CITY OF ALBUQUERQUE

Re: Encino Gardens Renovation
412 Alvarado DR SE
Traffic Circulation Layout
Architect's Stamp 10-02-23 (K18D002)

FIGURE 7.4.117 ADA Accessible Parking Stall and Access Aisle Dimensions

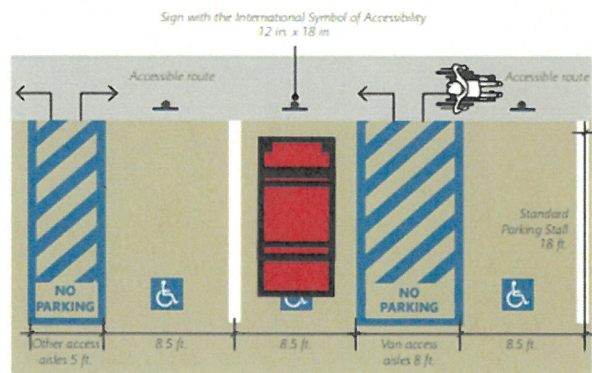
1. Since you are proposing gates, forward Fire Department approval.
2. Forward Solid waste approval.
3. In general, provide all ramp and landing slopes and sidewalk widths.
4. Provide signage in addition to pavement markings for the one-way exits and entrances: "One Way" and "Do Not Enter".
5. You will need a ramp at each end of the sidewalk that is being reconstructed (Keyed Note 3). Provide max ramp slopes. Max slope is 8.3%, but it is best to design to a lower maximum: 7.5%.
6. It is usually helpful to provide a detail of the layout of ADA Accessible parking. See below:
